**Operator: BCEI**

**Location Name: ANTELOPE 21-19 Pad**

**Loc ID: 418233**

**Inspection: 696306495**

Exhibit A

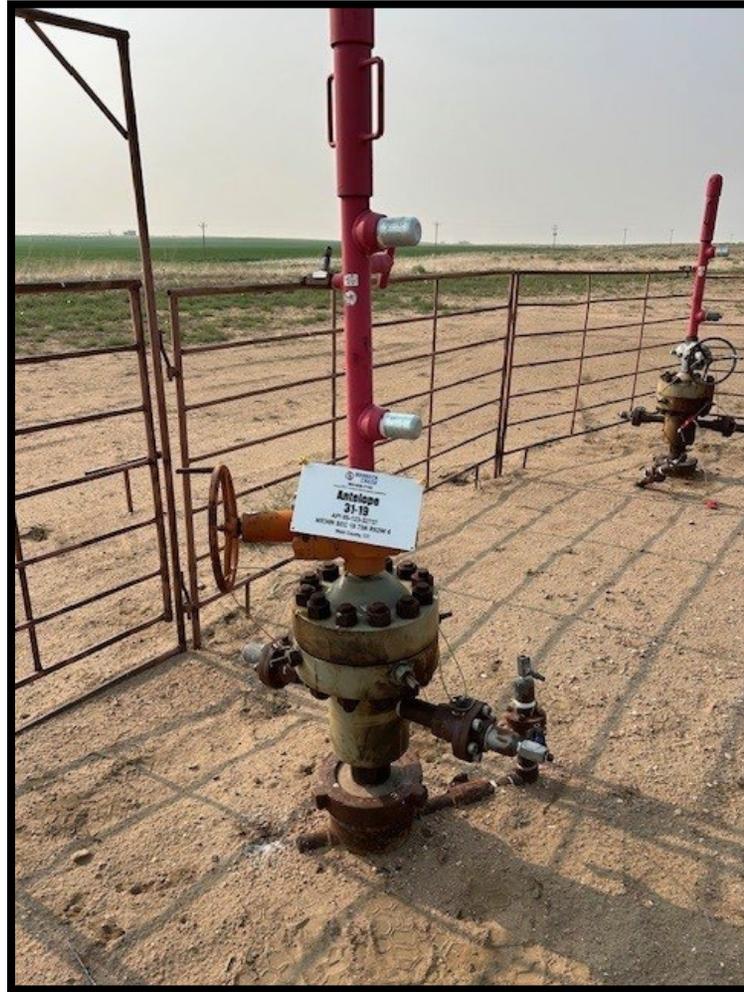
**CA:** L-19 (123-35125), 31-19 (123-32737) and K-19 (123-35127) Wellhead Signs have faded no longer visible. Install sign to comply with Rule 605.d.

**CA Resolution:** Operator has reported that signs have been appropriately updated for each of the listed wells to comply with the 600 series.
